LIGO CALIFORNIA INSTITUTE OF TECHNOLOGY MASSACHUSETTS INSTITUTE OF TECHNOLOGY	
SYSTEM	SUB-SYSTEM
ADVANCED LIGO	AOS
NEXT ASSY	
D1003349, D1200922

PART NAME				αLIGO, HAM4, SR2 SCRAPER BAFFLE, BK GLASS OVERLAY			
DESIGNER	E.SANCHEZ	07 JAN 2016	SIZE	D	DWG. NO.	D1600003	REV.
DRAFTER	E.SANCHEZ	07 JAN 2016					v7
CHECKER	SEE DCC	SEE DCC					
APPROVAL	SEE DCC	SEE DCC	SCALE:	1:2	PROJECTION:		SHEET 1 OF 1

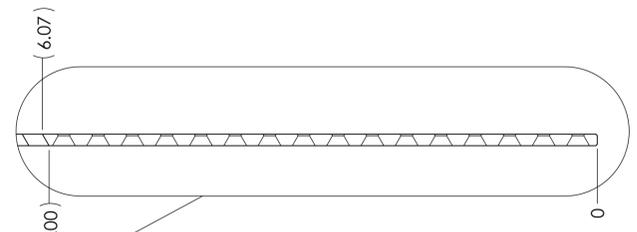
Back side. Surface scratch, about 1.5" long center top of glass.

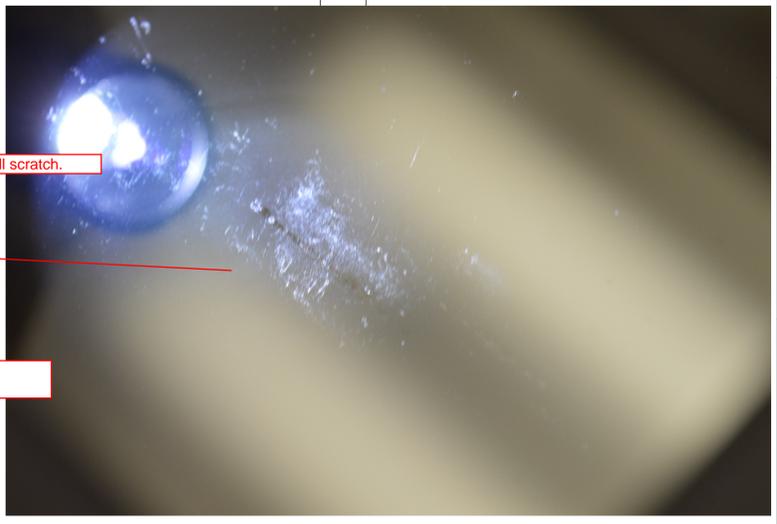
Small deep scratch.
